October 11, 2013

Subject: Response to Department of Toxic Substances Control Comments Regarding the “Draft Monitoring Well Installation Work Plan, Area 1, University of California Richmond Field Station”

Subject: Monitoring Well Installation Work Plan, Vicinity of the Biologically Active Permeable Barrier, University of California Richmond Field Station.

<b>SAFETY FIRST</b> 	CLIENT:	Zeneca, Inc.	<b>Site Plan with Proposed Monitoring Wells</b>  <b>FIGURE 1</b>
	PROJECT:	Campus Bay Richmond, CA	
	PROJECT NUMBER:	0009.002.007

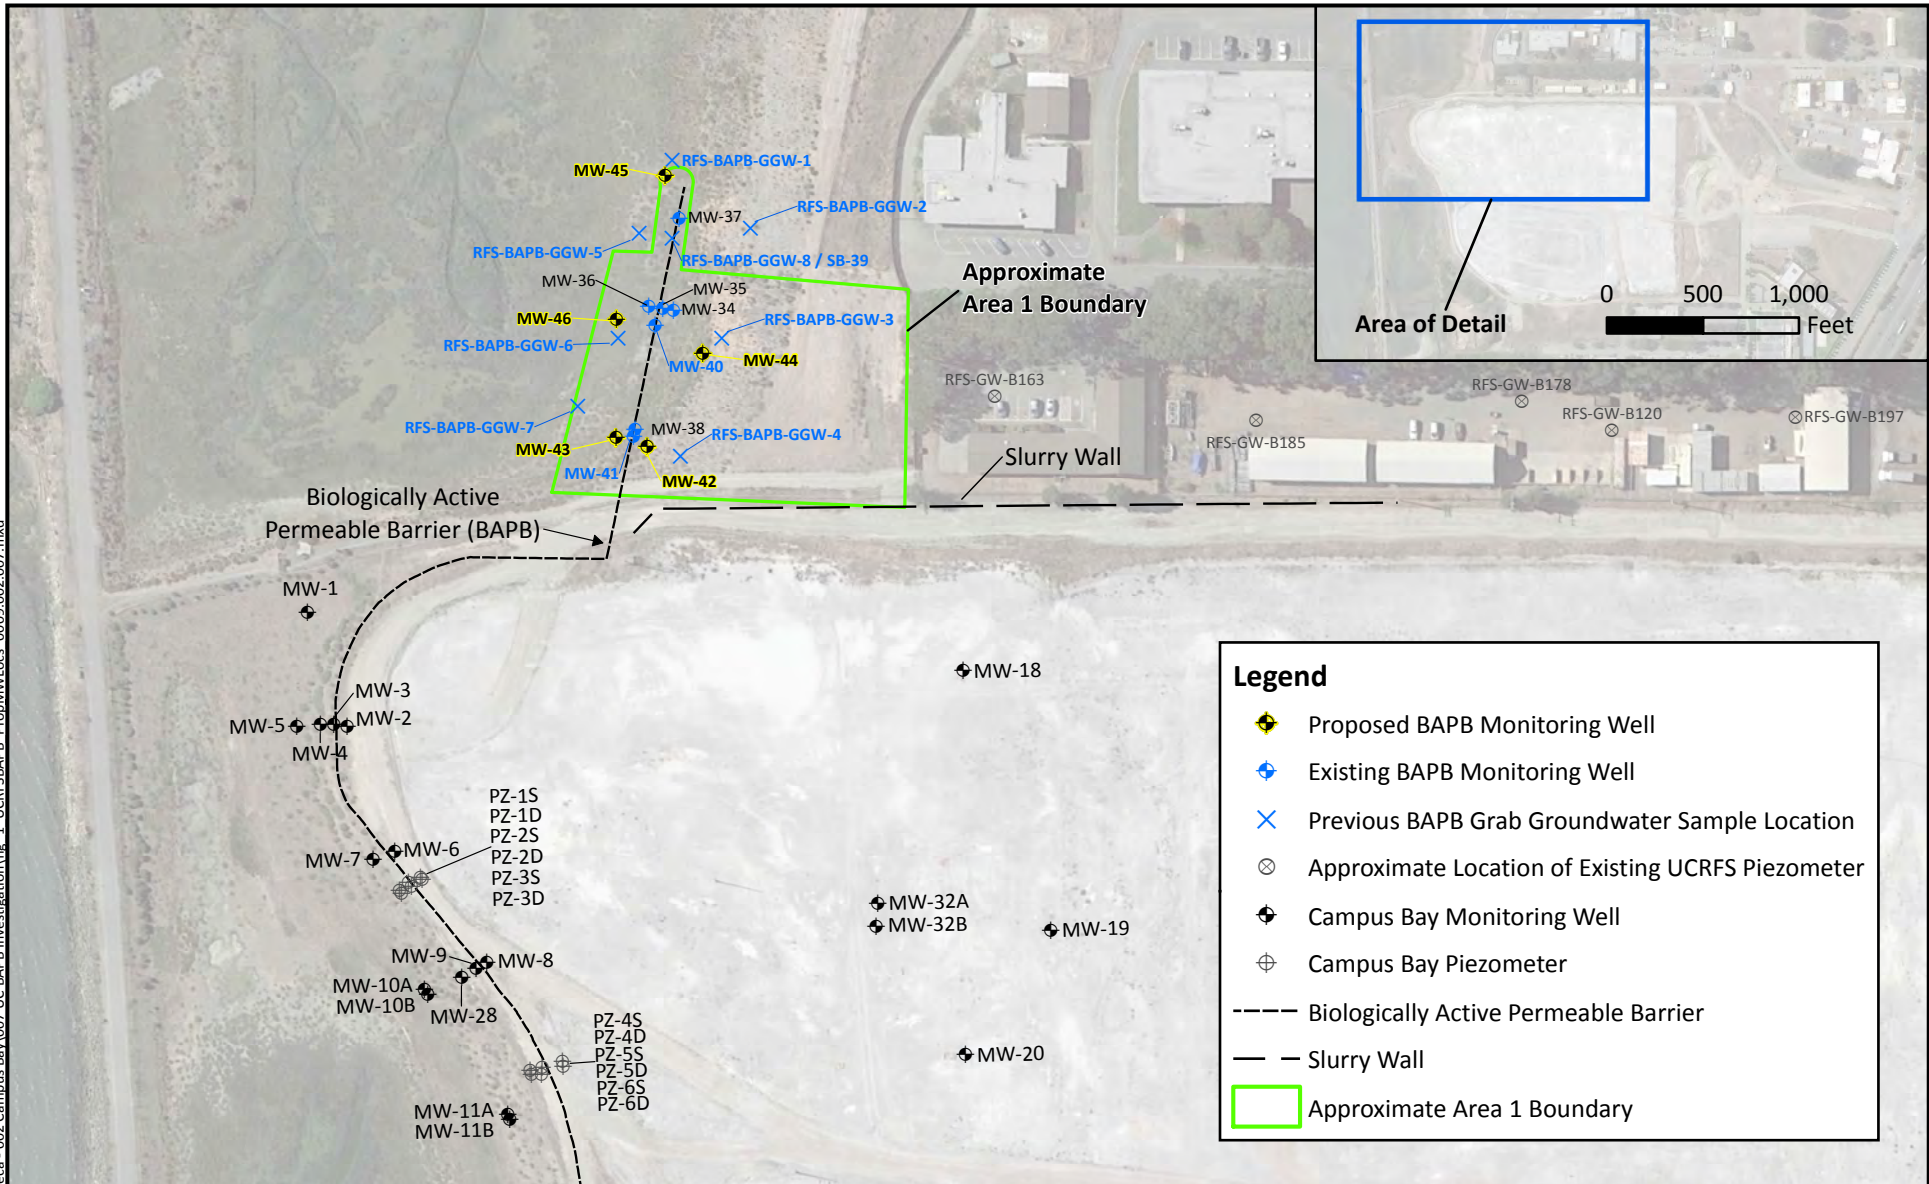
*"Page 3 describes the target screen interval for the proposed wells to be 5 to 15 feet below ground surface based on the construction of the existing wells in the area. In order to avoid placement of the screen interval at or below the BAPB material (such as what may have occurred at well MW-35), language should be inserted into the text discussing how to avoid this potential problem."*

To address this comment, the text within the, "Monitoring Well Installations" section of the work plan has been amended to include the discussion in bold italics below:

*"The monitoring wells will be installed at the approximate locations illustrated on Figure 1 using hollow stem auger (HSA) technology by a California-licensed drilling contractor under the supervision of a Terraphase California Professional Geologist. **The screen interval for each monitoring well will be constructed at a depth interval that will allow for the assessment of shallow groundwater above the bottom of the BAPB. The purpose of each monitoring well is discussed below:***

- *MW-42: To assess groundwater upgradient of the BAPB and assess the performance of the BAPB.*
- *MW-43: To assess groundwater downgradient of the BAPB and assess the performance of the BAPB.*
- *MW-44: To assess groundwater upgradient of the BAPB.*
- *MW-45: To assess groundwater downgradient and to the west of the BAPB.*
- *MW-46: To assess groundwater downgradient of the BAPB."*

Terraphase will use the lithology information obtained during the previous investigation in conjunction with the lithology recorded at each proposed monitoring well location to properly position the well screen. If well screens are required to be shortened or modified as compared to the specifications provided in the Work Plan, the modifications will be identified and described in the well installation report. No further changes to the Work Plan are required at this time.
